**ADDENDUM NO. 3**

**PROJECT NO. DGS C-0503-0026 PHASE 001**

**PROJECT TITLE - North Central STU - HVAC Upgrades**

**DRAWING CHANGES – ALL CONTRACTS**

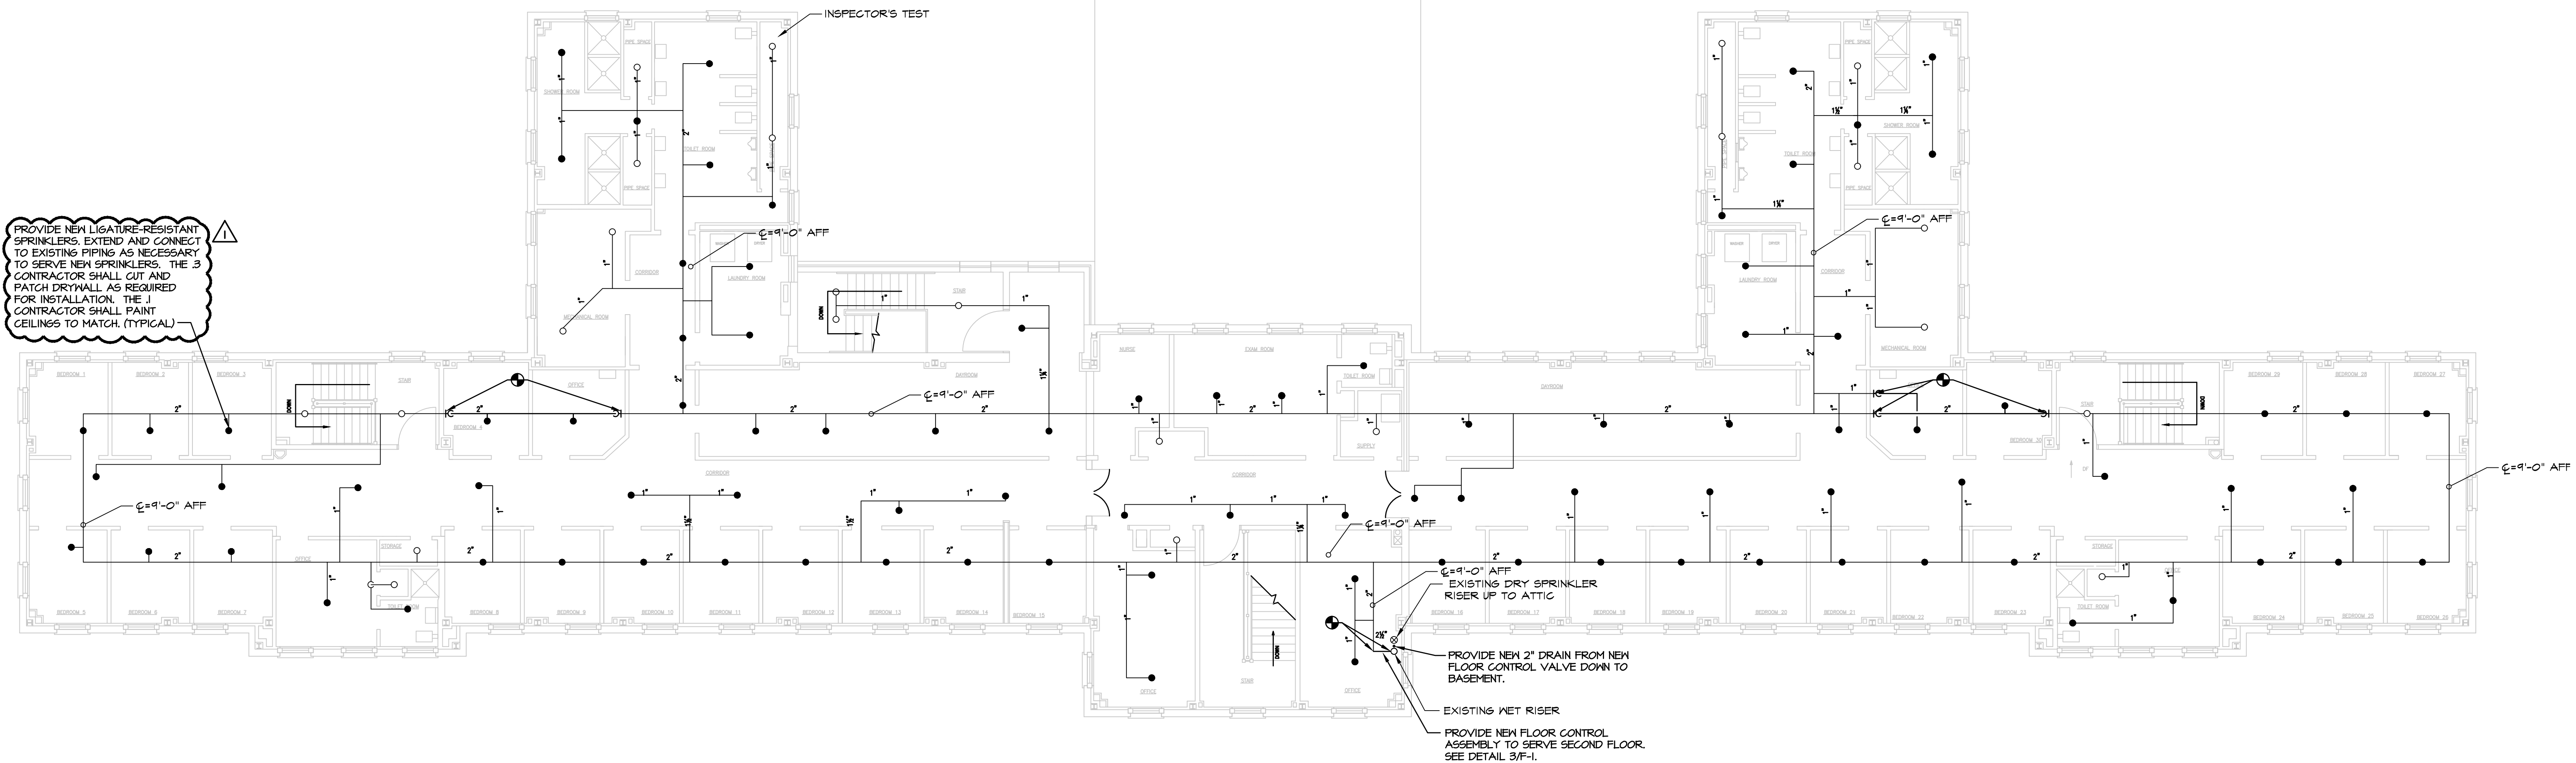
Item 2 - Drawing E-5 Green Building Electrical Schedules - Revised panel schedules to accommodate AH and CU changes.

**FIRST AND SECOND FLOOR PLANS - GREEN BUILDING - FIRE PROTECTION**

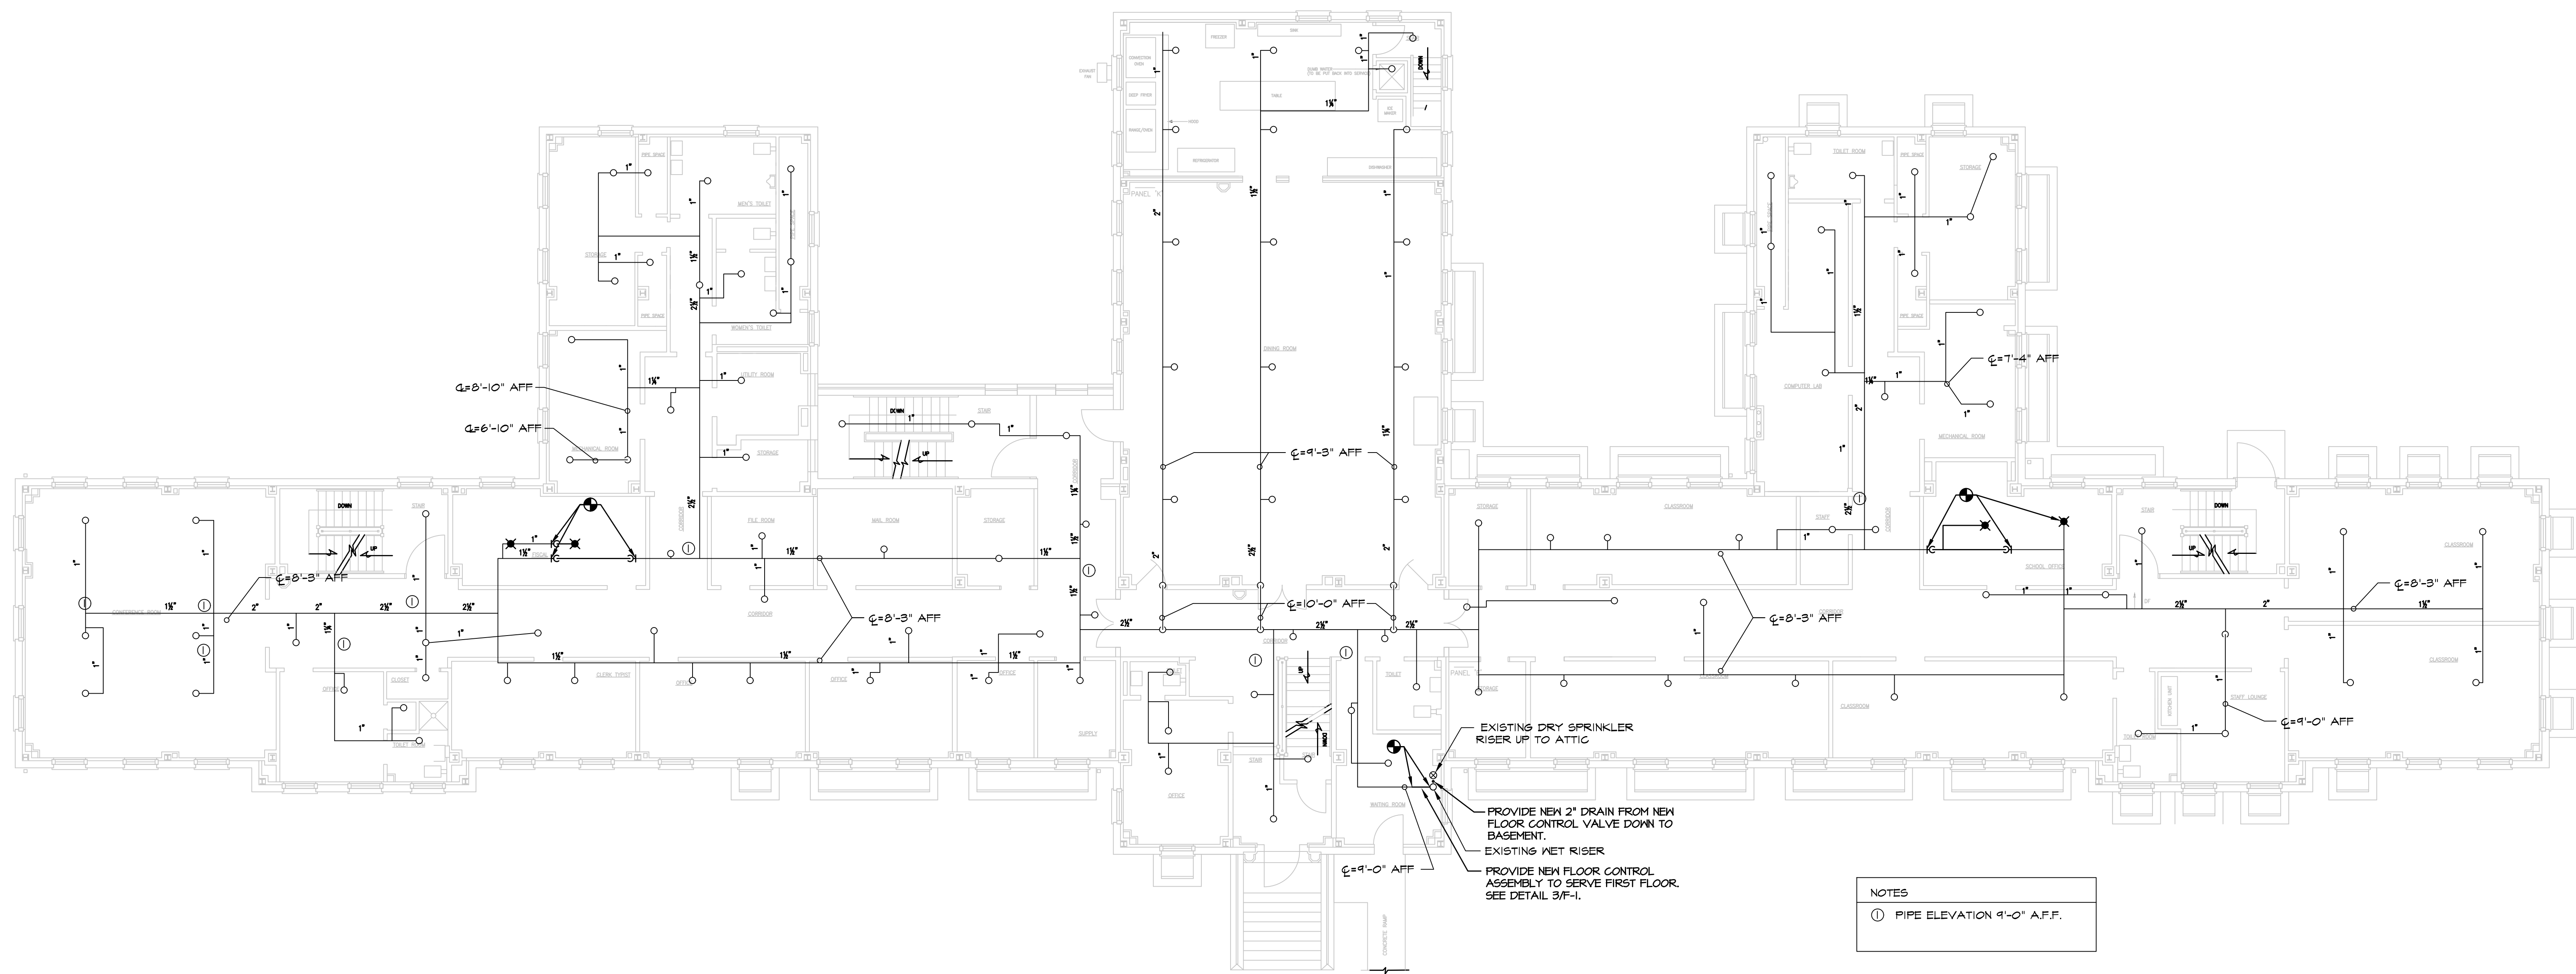
Item 1 - Drawing F-4 Green Building First and Second Floor Plans Fire Protection - Revised note pertaining to sprinkler replacements in rooms with gypsum board ceilings.

NOTES  
 ① PIPE ELEVATION 9'-0" A.F.F.

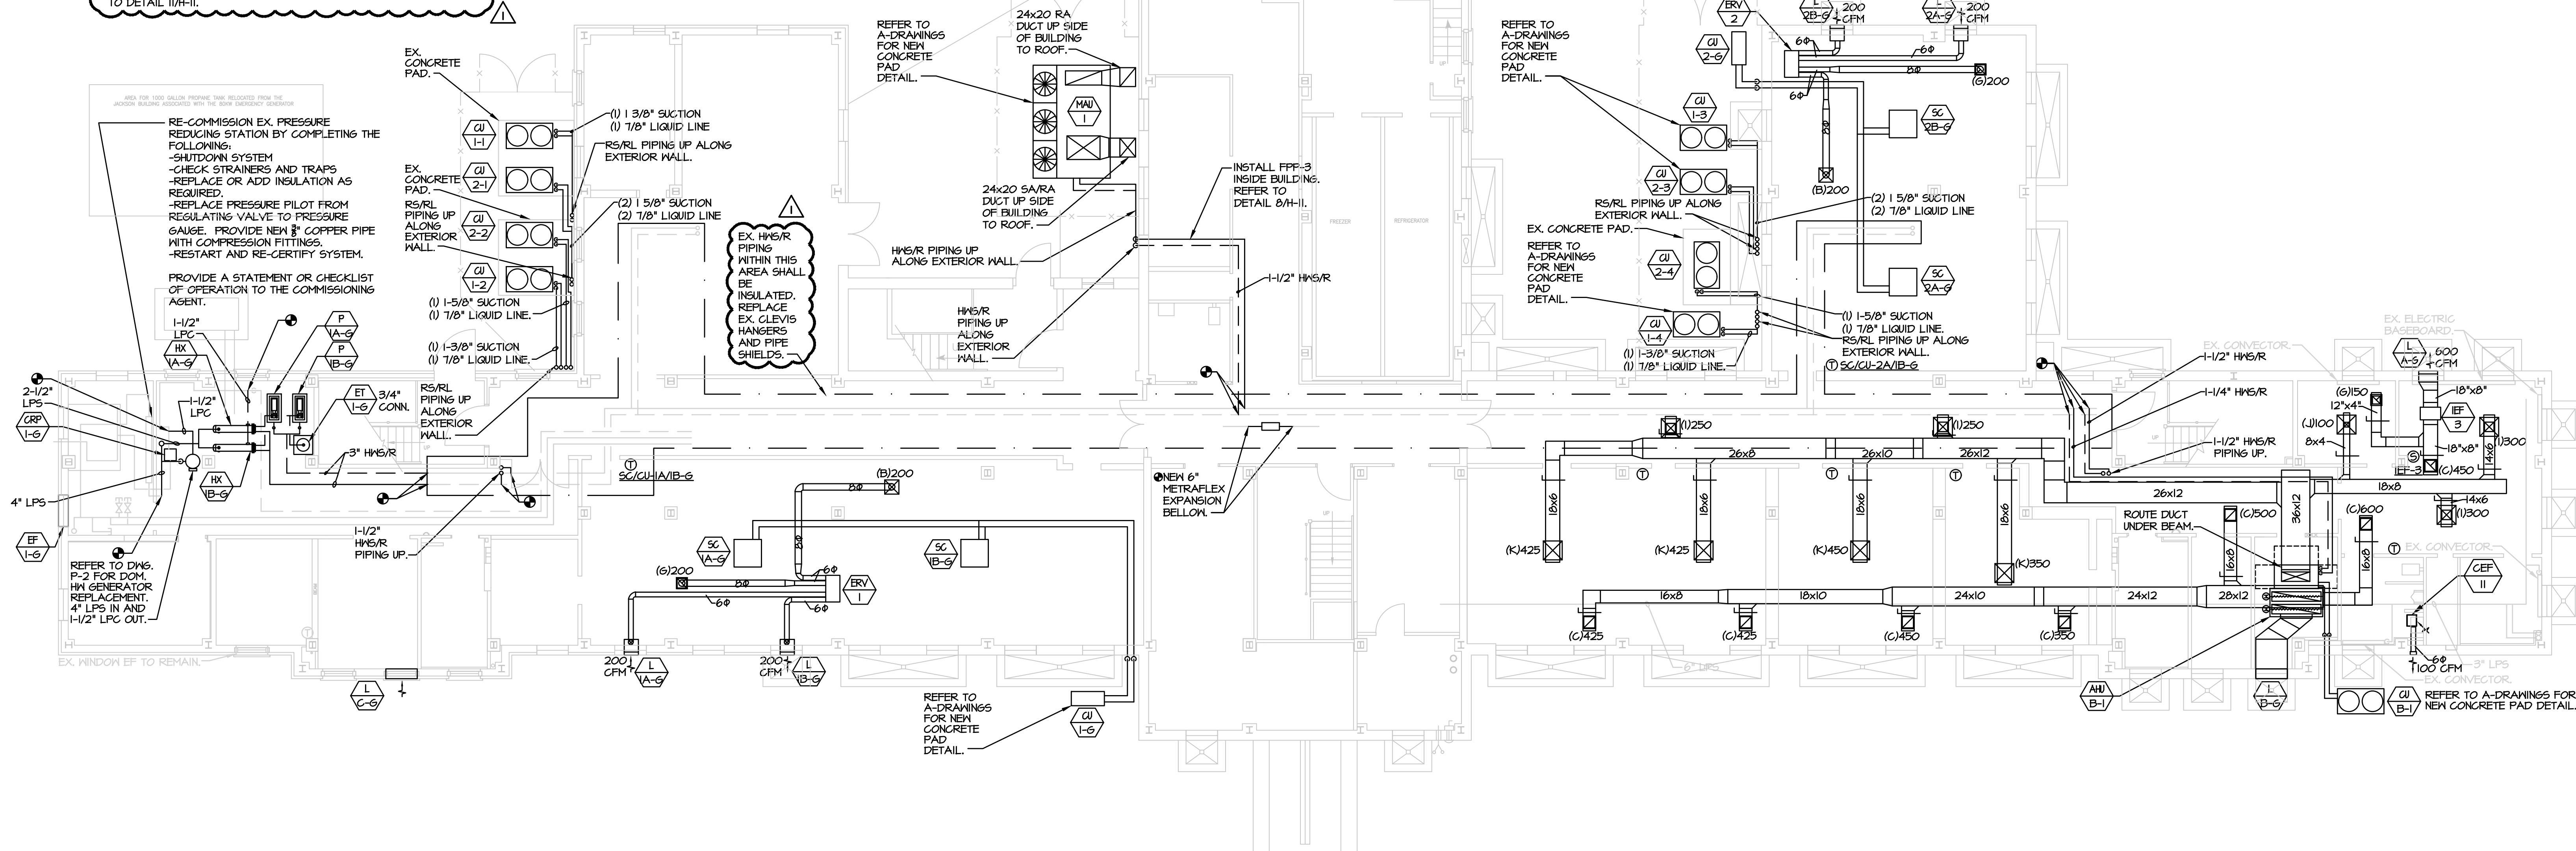
Item 5 - Drawing H-12 Schedules - Revised AH and CU schedules.
